APPLICATION FOR PERMIT TO DRILL						1. WELL NAME and NUMBER Haueter 14-7-3-1W					
2. TYPE OF WORK DRILL NEW WELL <input checked="" type="checkbox"/> REENTER P&A WELL <input type="checkbox"/> DEEPEN WELL <input type="checkbox"/>						3. FIELD OR WILDCAT WILDCAT

Newfield Production Company
Haueter 14-7-3-1W
SE/SW Section 7, T3S, R1W
Duchesne County, UT

**Application for Permit to Drill
Statement of Basis
Utah Division of Oil, Gas and Mining**

FIGURE #3

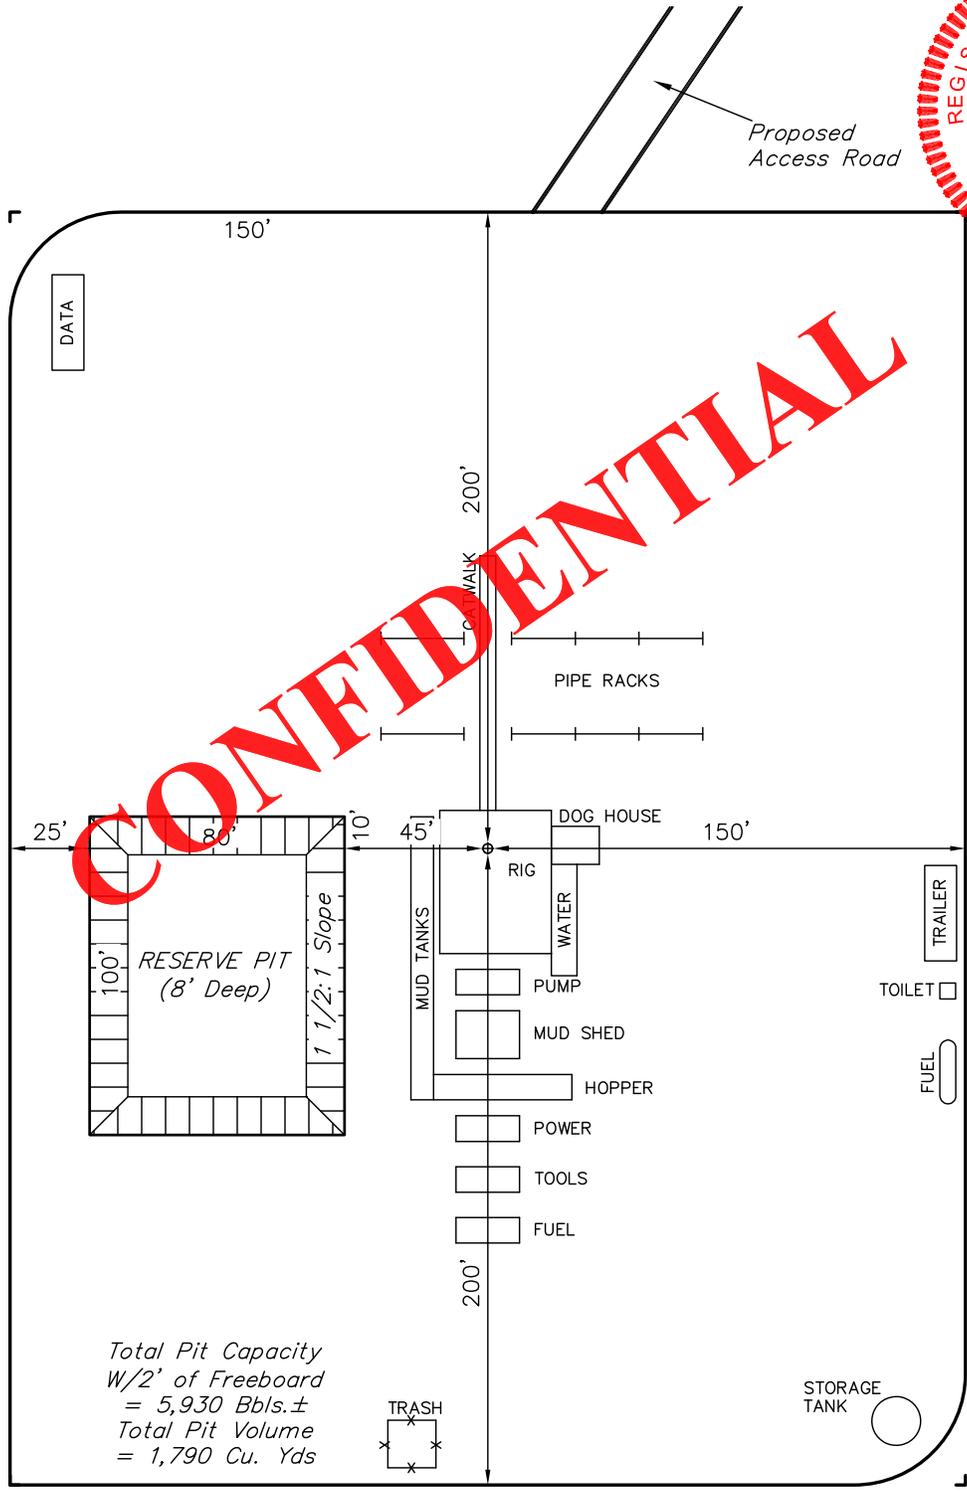
Category	Condition
Pits	A synthetic liner with a minimum thickness of 16 mils with a felt subliner shall be properly installed and maintained in the reserve pit.

Casing Schematic

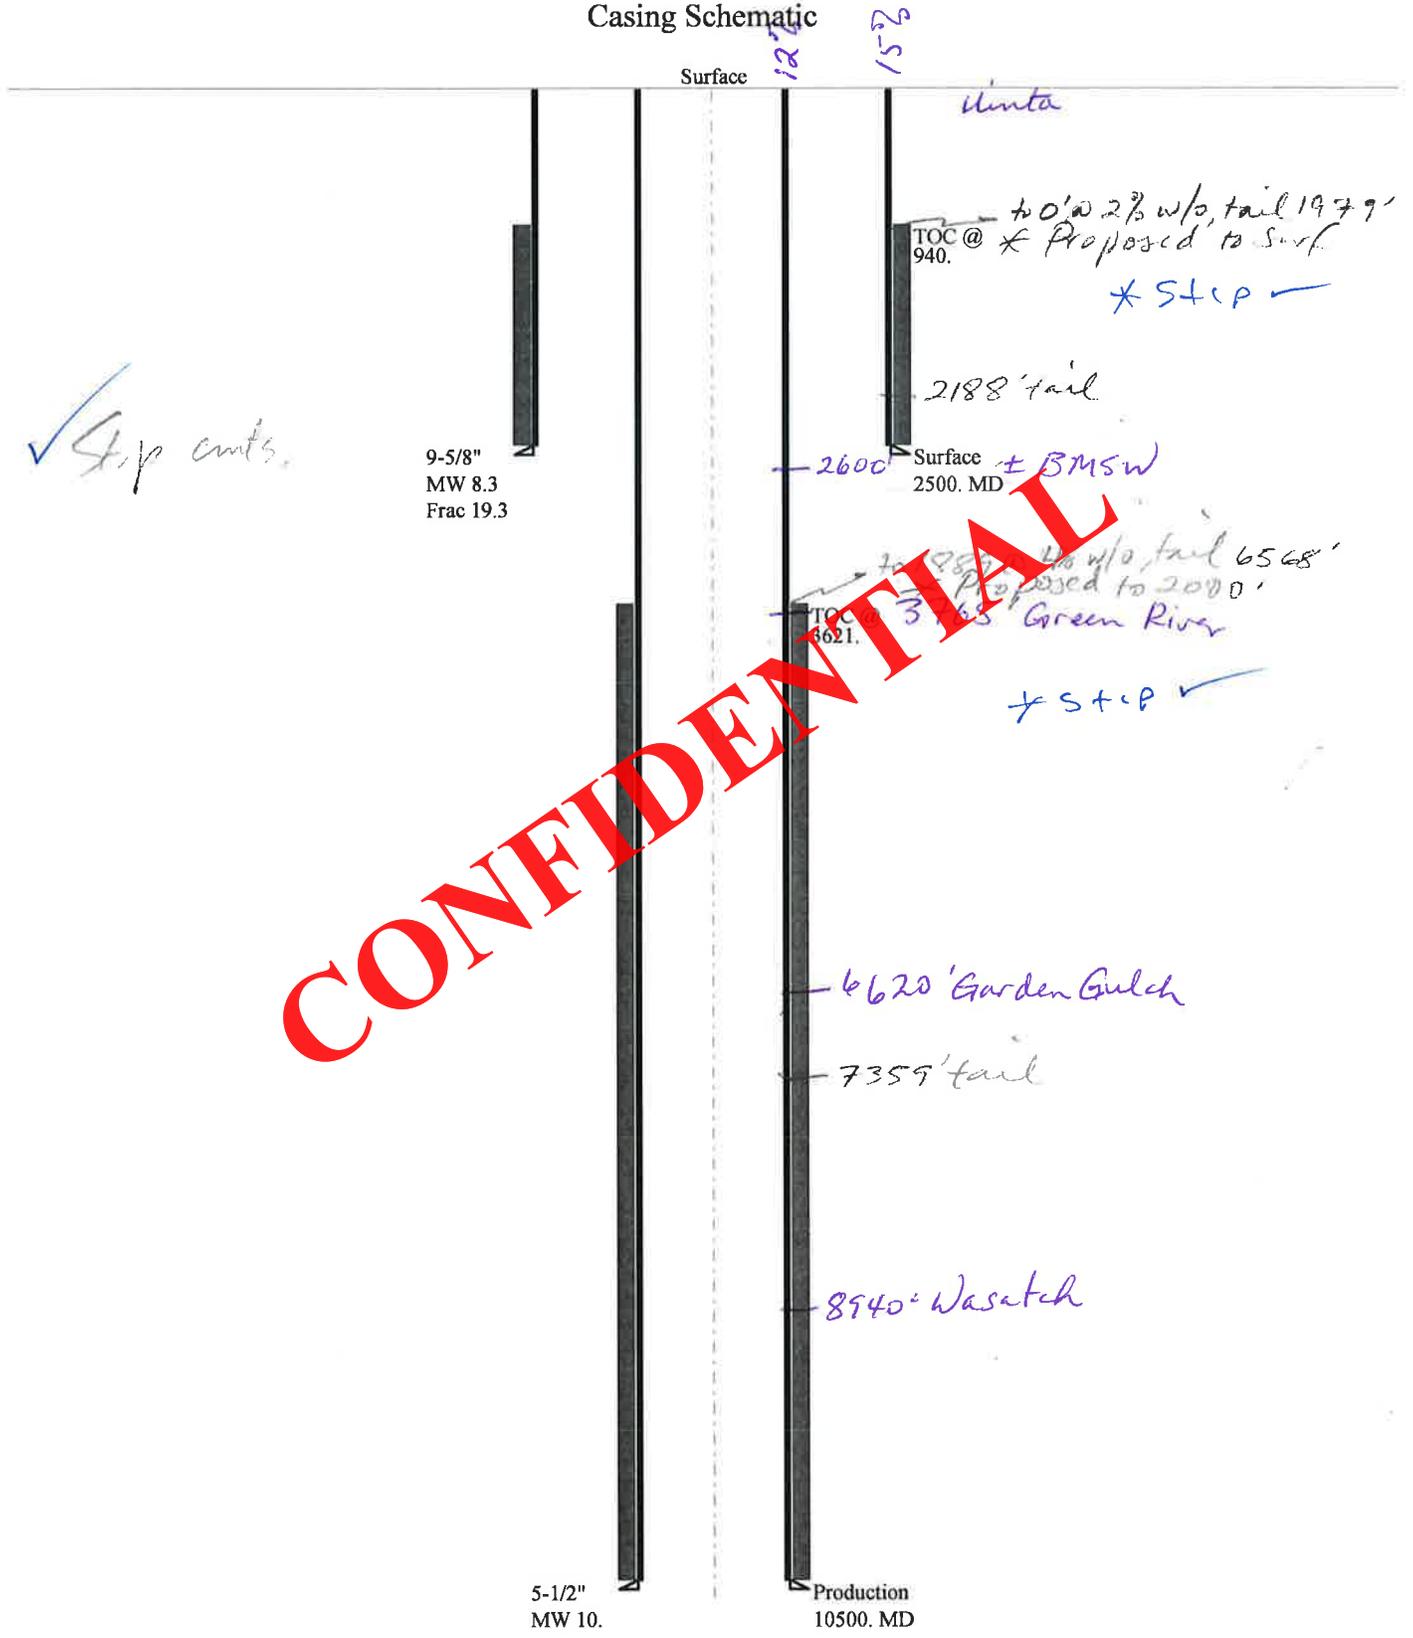
Collapse is based on a vertical depth of 2500 ft, a mud weight of 8.3 ppg. The casing is considered to be evacuated for collapse purposes. Collapse strength is based on the Westcott, Dunlop & Kemler method of biaxial correction for tension.

Burst strength is not adjusted for tension.

Collapse is based on a vertical depth of 10500 ft, a mud weight of 10 ppg. The casing is considered to be evacuated for collapse purposes. Collapse strength is based on the Westcott, Dunlop & Kemler method of biaxial correction for tension.

Burst strength is not adjusted for tension.
